ADDENDUM NO. 2

Elm Road Elementary School – Interior Improvements

Penn-Harris-Madison School Corporation  
Mishawaka, Indiana

Project No. 223211.00

POWER PLAN UNIT A  
DRAWN BY: AV  
CHECKED BY: WMH  
COMM. NO.: 8455.00  
DATE: 11 NOV. 1985  
REVISIONS NO. DATE  
EX-E6

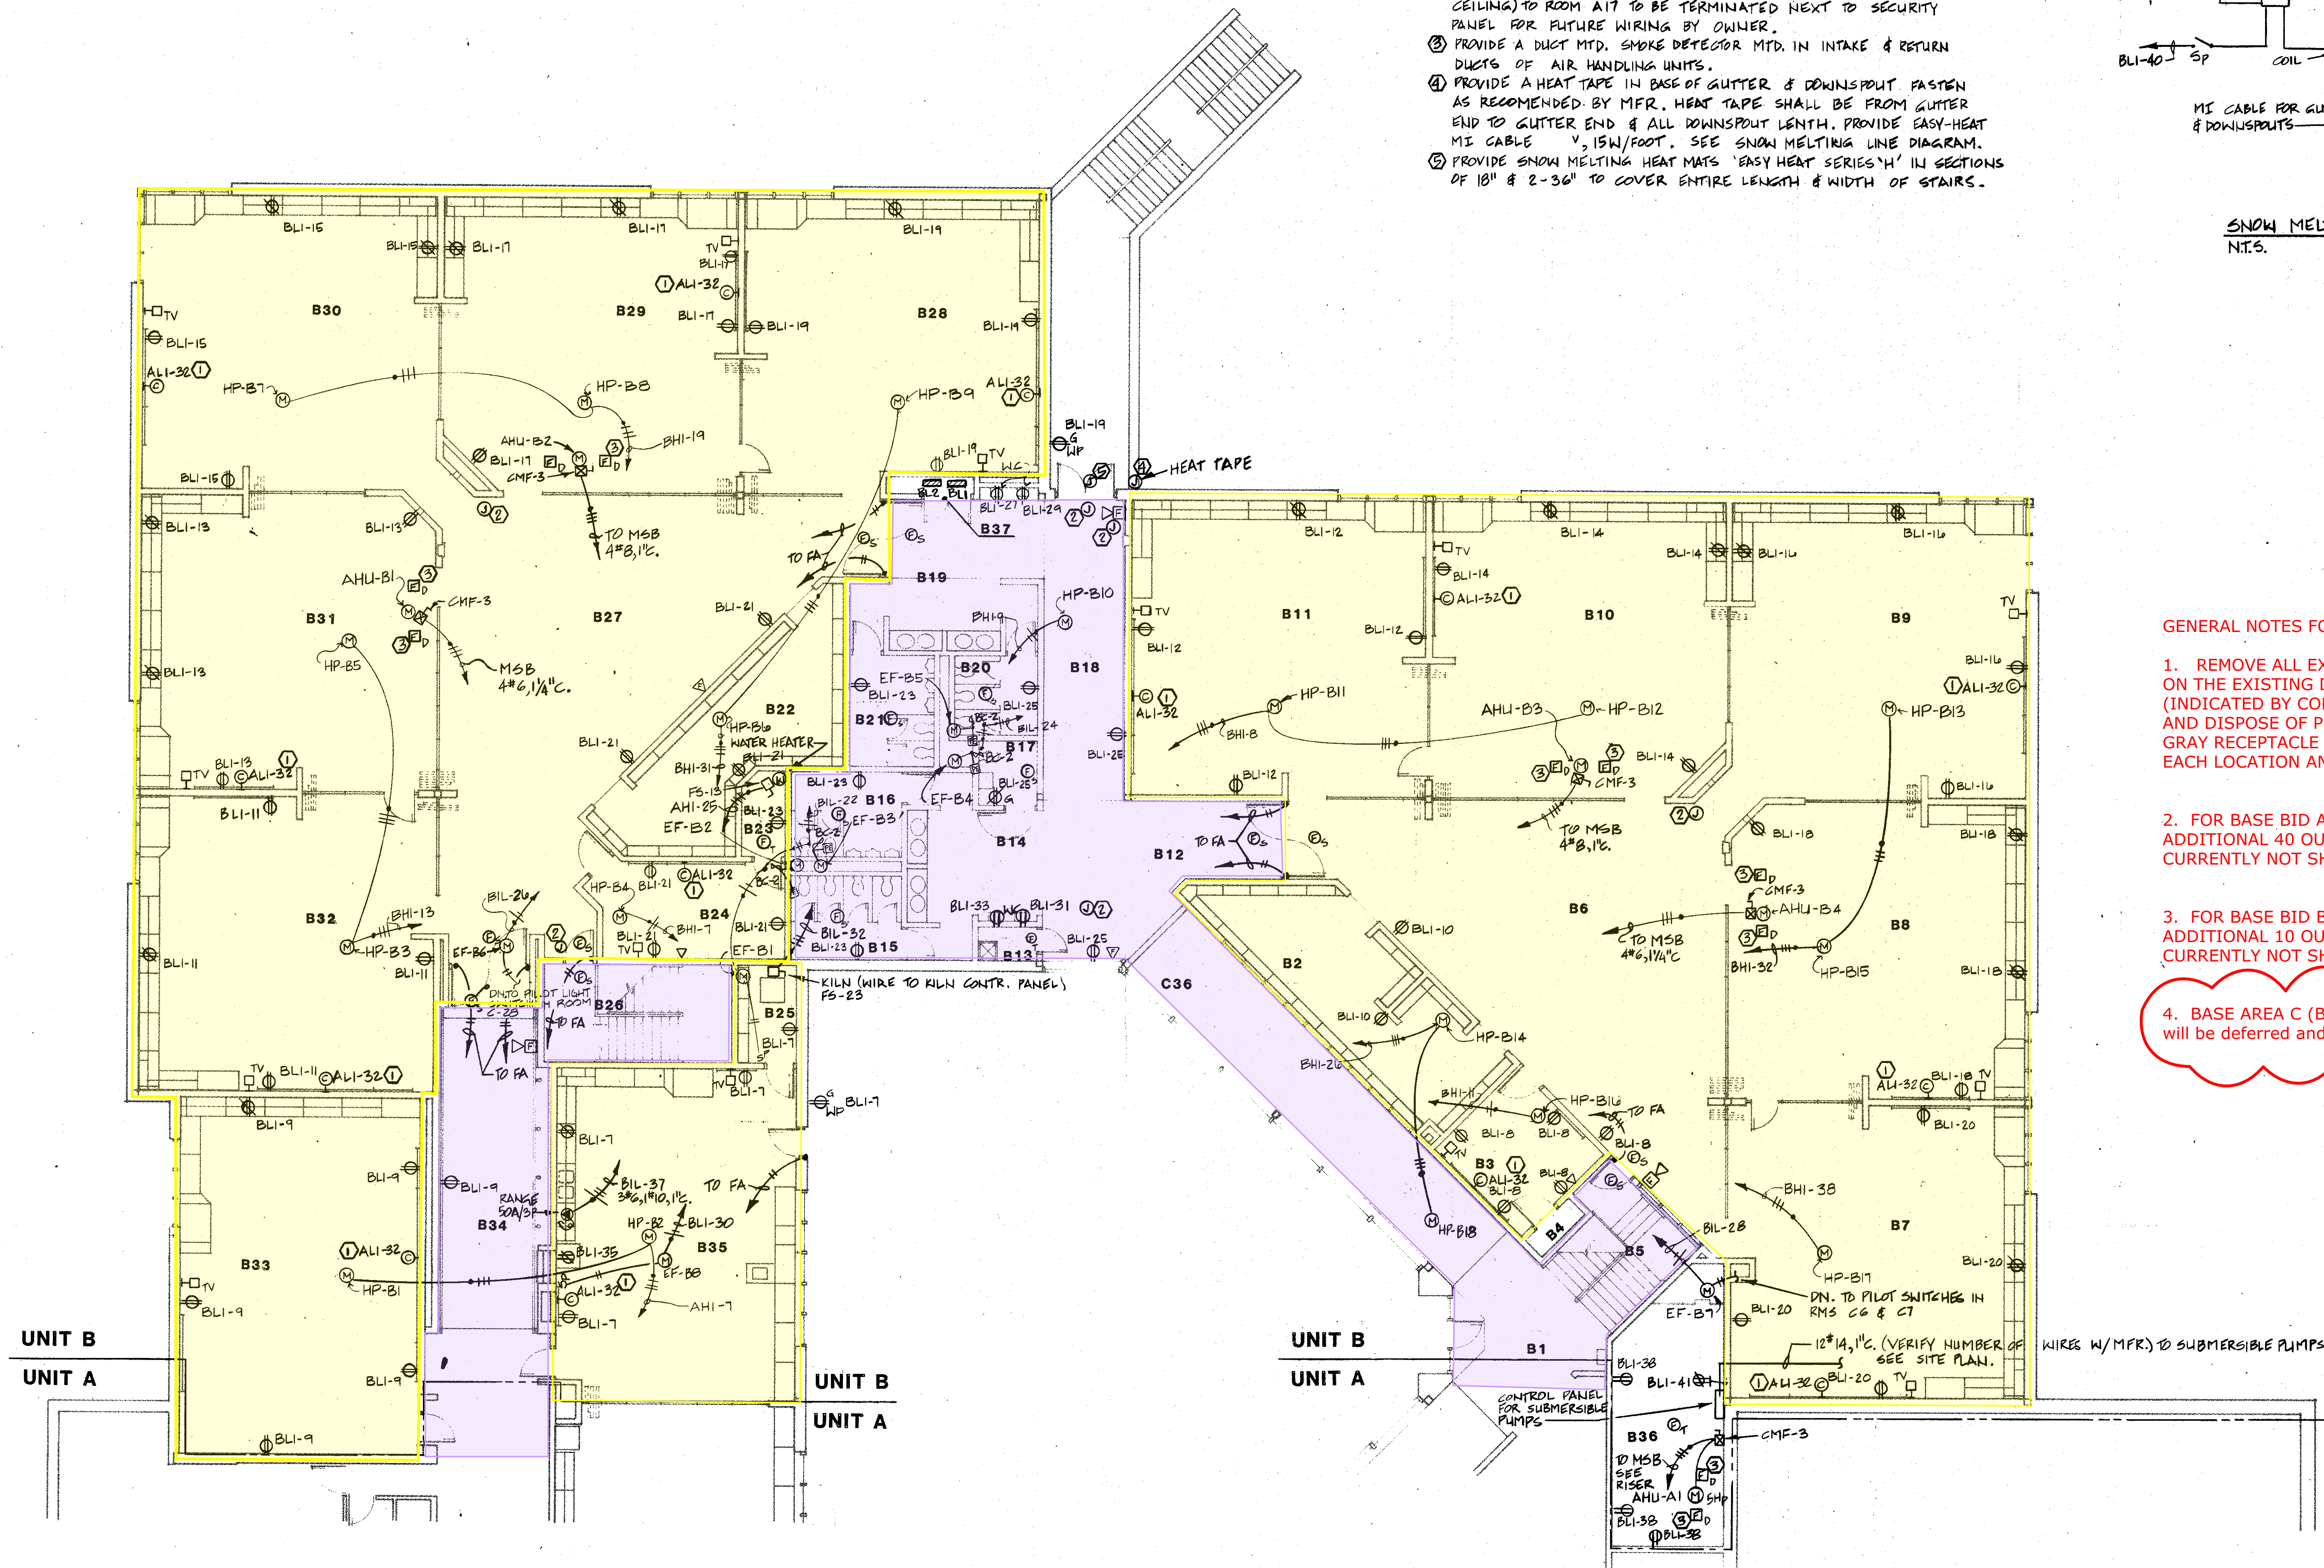
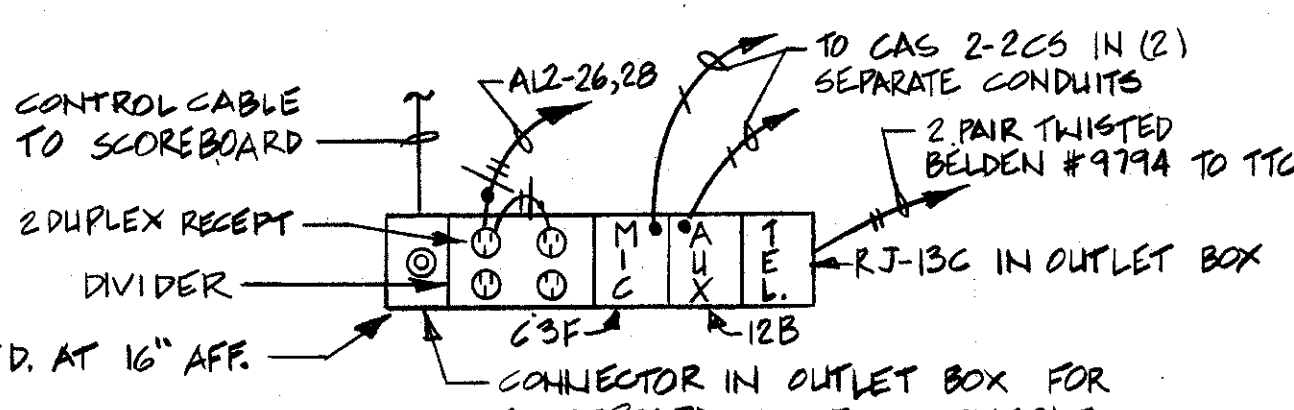
- A. Existing Drawings: EX-E6, EX-E7, EX-E8, V1, V2, and V3 have been revised to defer Base Bid C scope, dated 3/19/24, and are included with and hereby made a part of this Addendum. These Drawings supersede the original documents.

4. BASE AREA C (BLUE AREA). Not in Contract. This work will be deferred and considered future.

V-1

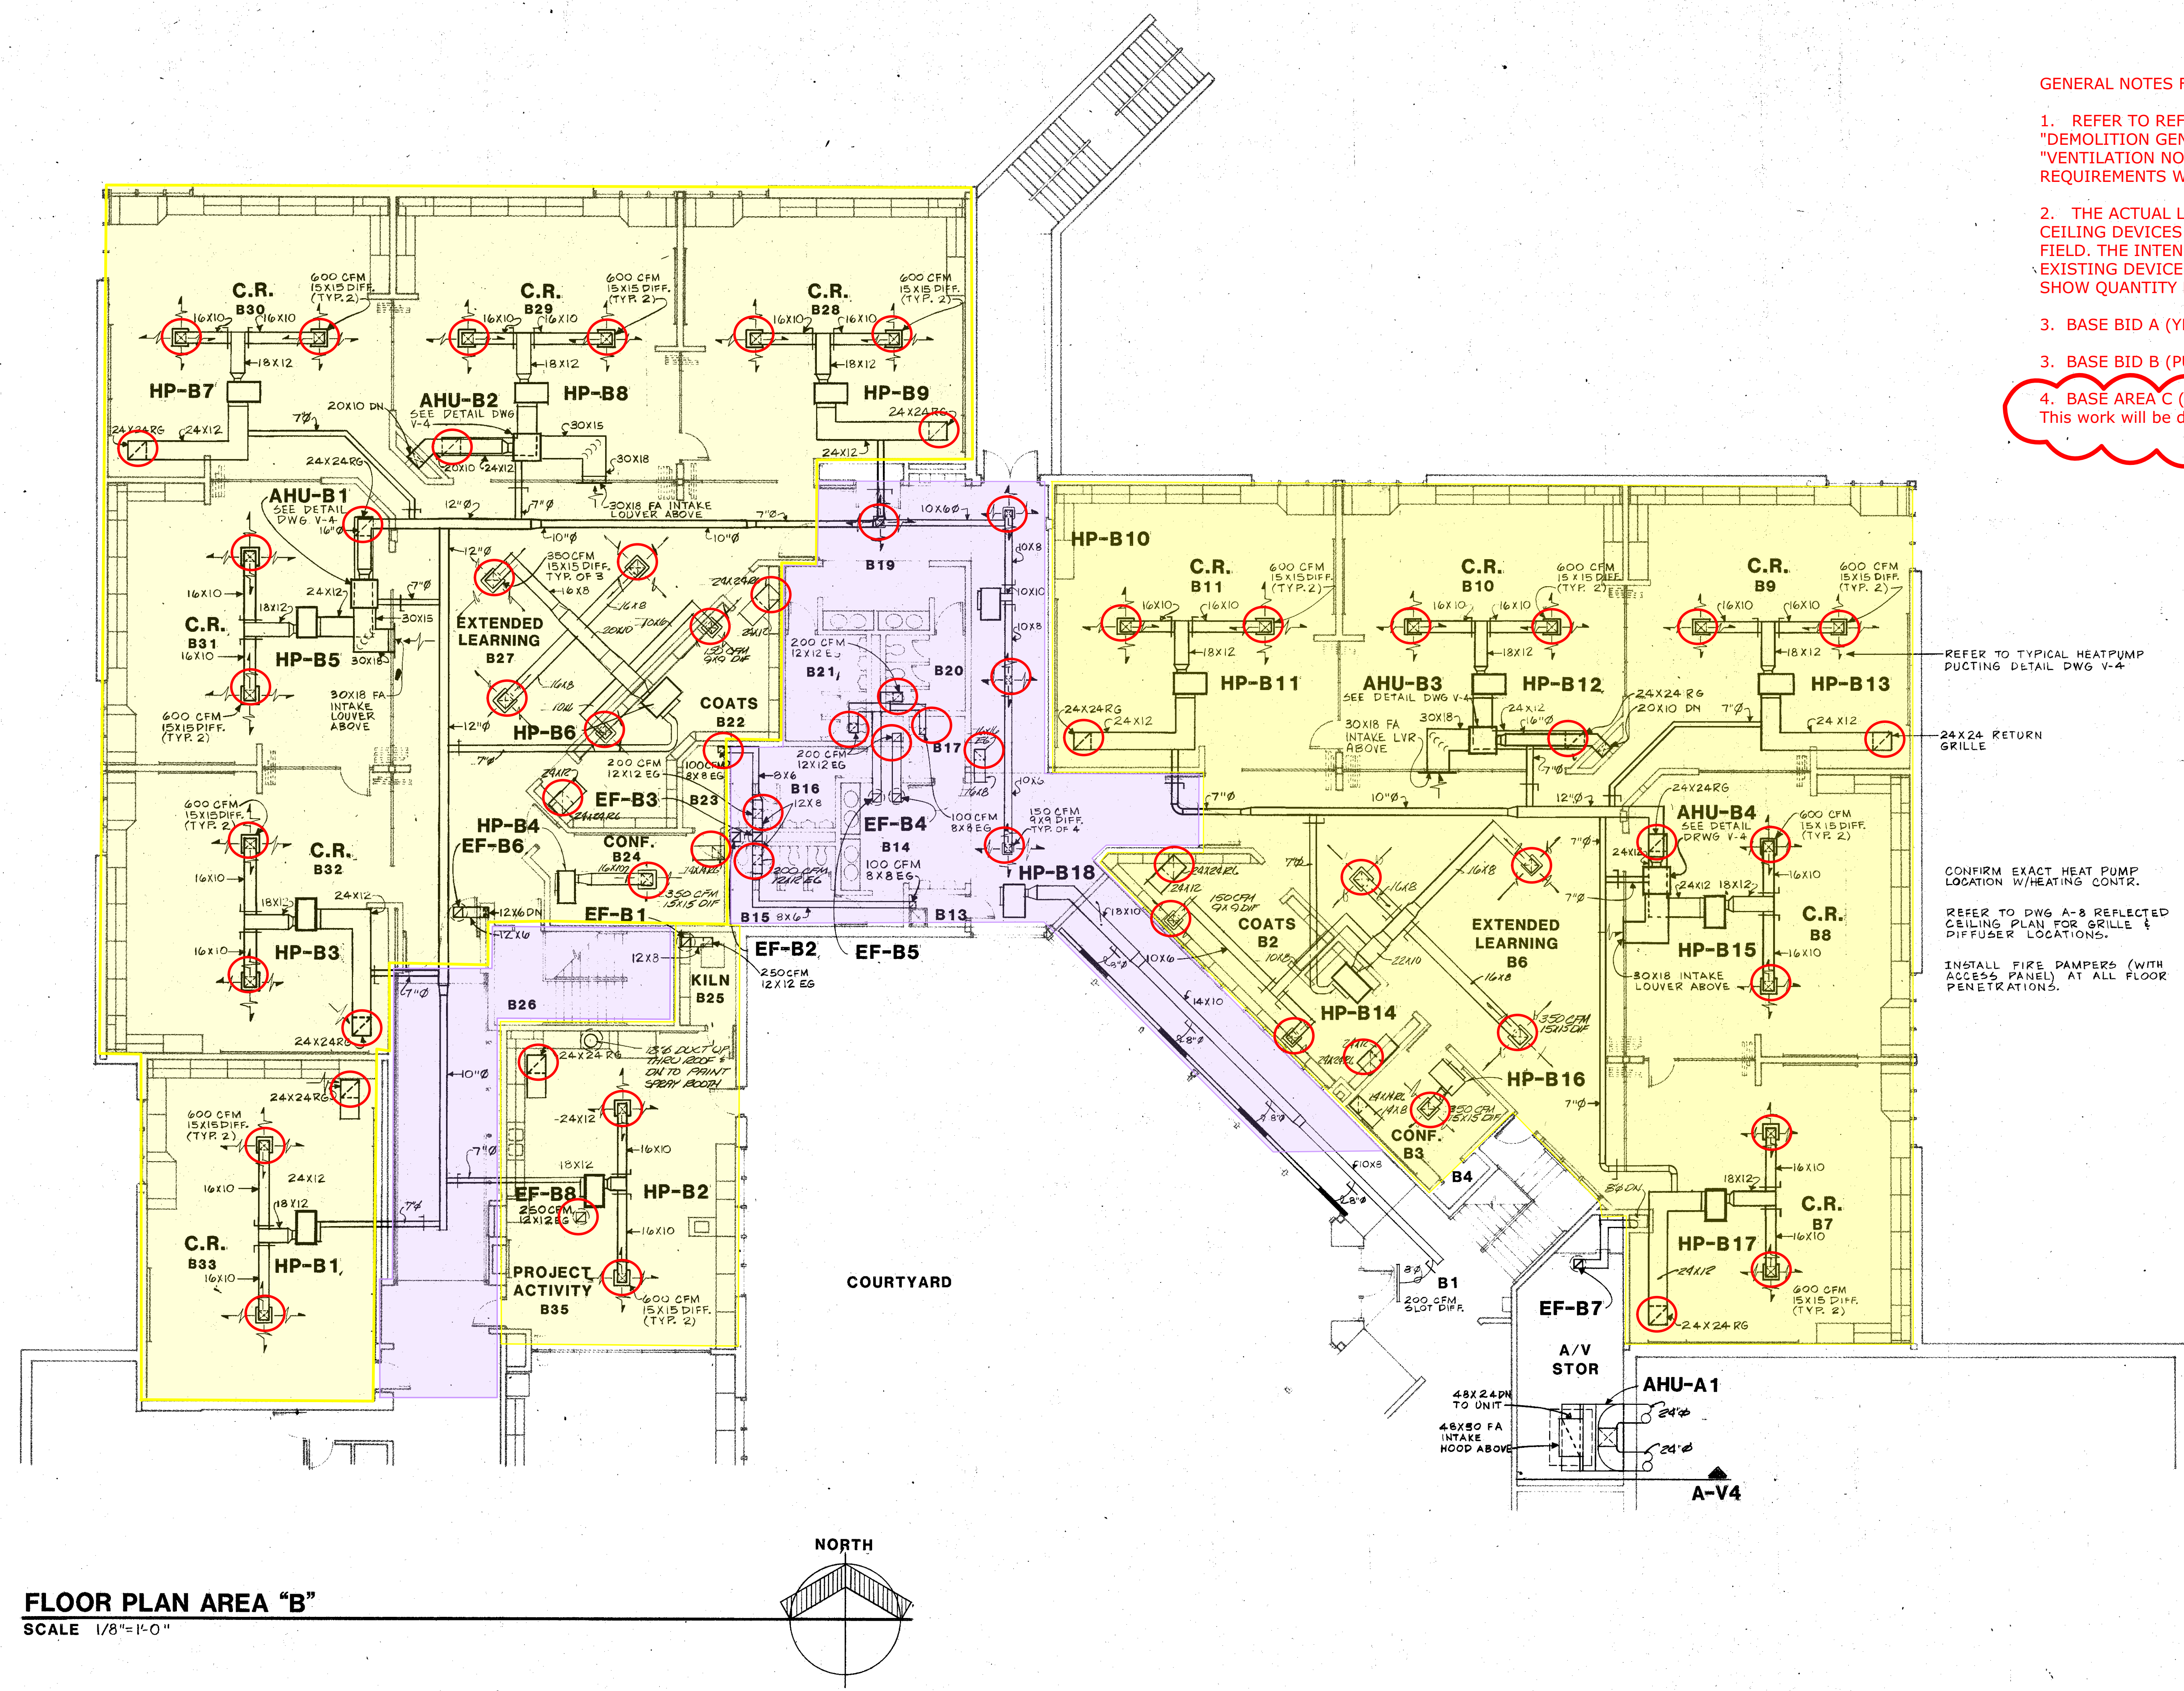
4. BASE AREA C (BLUE AREA). Not in Contract. This work will be deferred and considered future.
